MODIFICATION RECOMMENDED

6812B-03

S E R V I C E N O T E

6812B AC Source/Analyzer

Figure 1. A7 Inverter PCA Top View

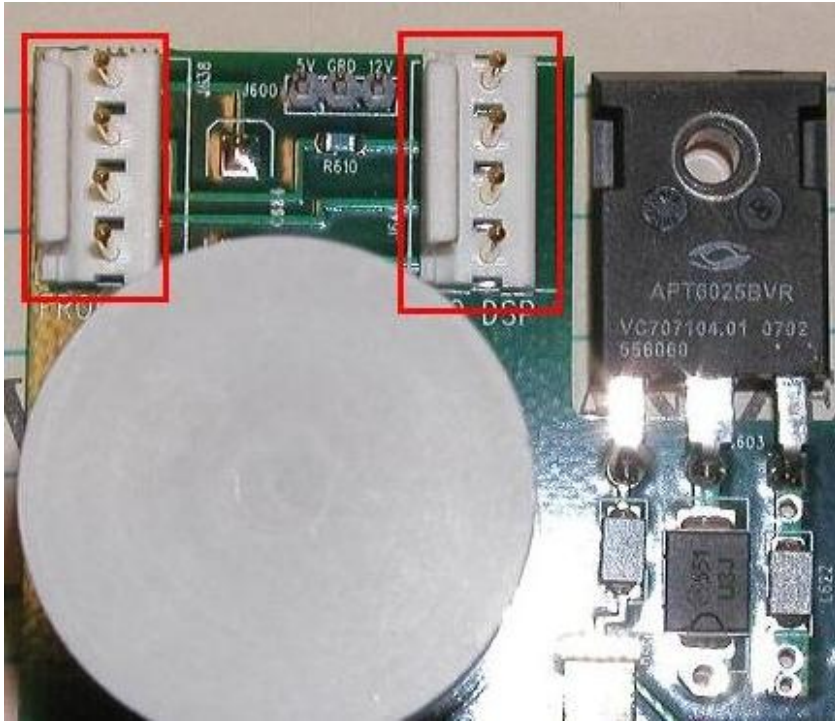
The first two connector headers are J638 and J646 on the A7 Inverter PCA. They need to be changed to the four pin connector, part number 1253-7410. These connectors should be fairly easy to de-solder.

Figure 3. A7 Inverter PCA Top View

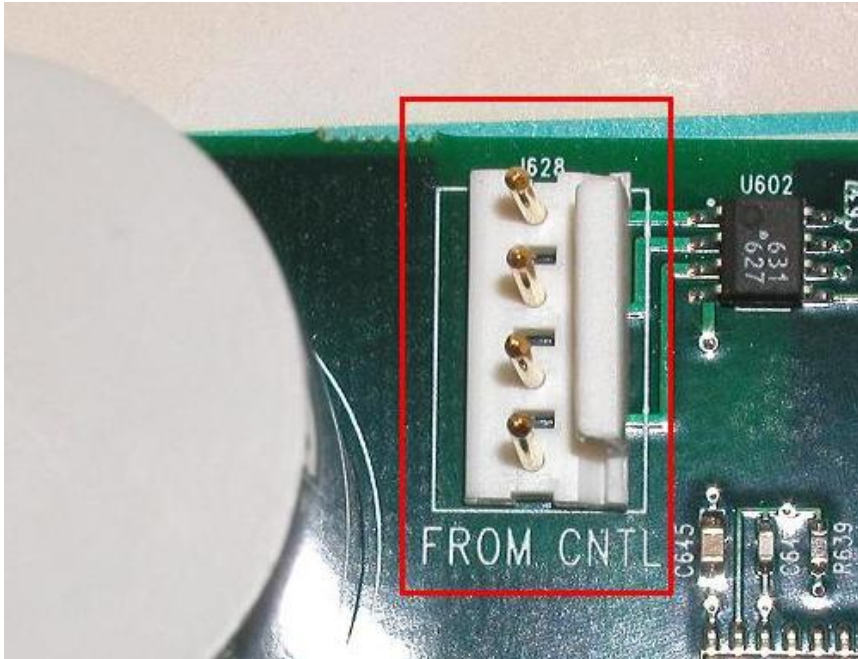
J628 on the A7 Inverter PCA also needs to be changed with part number 1253-7410. This should also be easy to de-solder.

Figure 5. A8 DSP PCA Top View

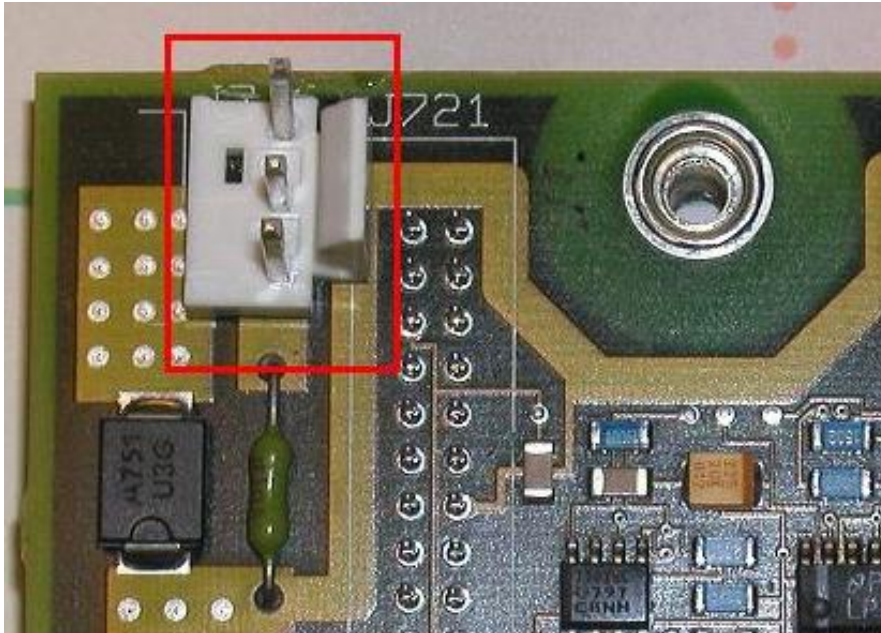
J721 on the A8 DSP assembly must also be changed. This is a three pin connector and should be changed to part number 1253-7460. This connector is hard to de-solder due to it being on top of a ground plane so extra care must be taken in order to avoid damaging the PCA. It is recommended to use solder wick instead of a de-soldering station.
